SUBJECT: #275-07(2) DENNIS & SVETLANA MIRVODA petition for a SPECIAL PERMIT/SITE PLAN APPROVAL to alter by more than three feet the existing contours of land for a retaining wall at 121 HARTMAN ROAD, NEWTON CENTRE, Ward 8, on land known as Sec 82, Blk 15, Lot 45, containing approx. 10,424 sf of land in a district zoned Single Residence 2.

Re: Special Permit – 121 Hartman Road Retaining Wall

*Site Plan 121 Hartman Road
Newton, MA
Prepared by: RAV Associates
Dated: 8/20/'06
Revised: 5/9/'08*

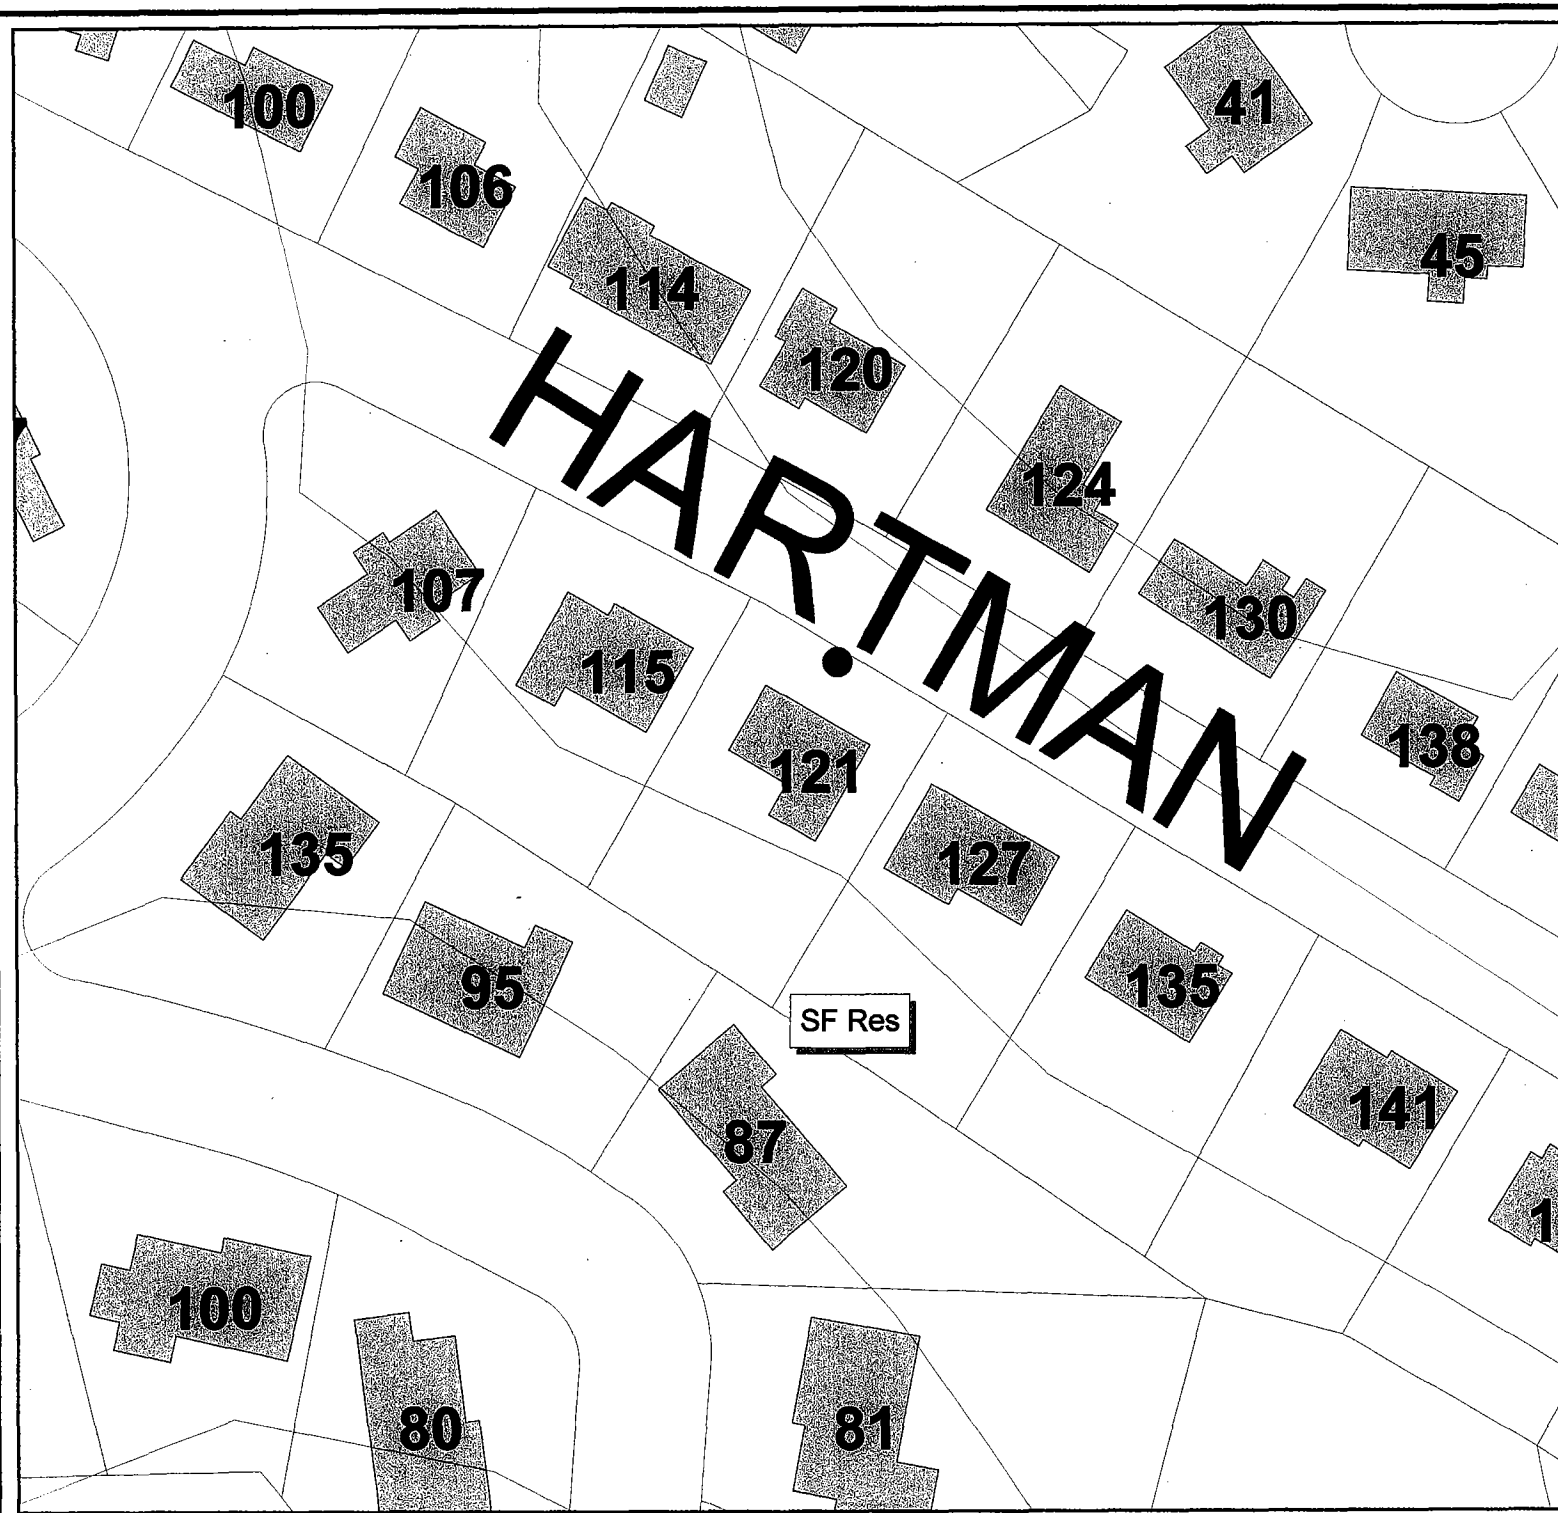
1. The revised site plan shows that the new proposed retaining wall has been pulled away from both abutters' properties and it appears that there should not be any negative impact. The contractor of record should however be careful during all phases of the construction so that no damage occurs to either abutter's property.
2. Based on the notes the existing concrete block walls will remain in place and only portions of the wall will be removed to just below grade, this is acceptable.

3. Based on a top of wall elevation of 112 feet as indicated, and a bottom of the wall at 105.5 feet based on cross-section #3, some sort of a safety/security fence will be needed. A detail of this safety fence or rail is needed and it shall conform to the requirements of the Inspectional Services Department.
4. Since the proposed wall is a structural retaining wall, and based upon the notes from the engineer of record, material for the leveling pad shall be compacted to 95% of the maximum proctor density (ASTM D698); this will require certified density testing by a professional engineer and certified reports shall be submitted to the Inspectional Services Department. **This is a critical requirement for the safety of the wall.**
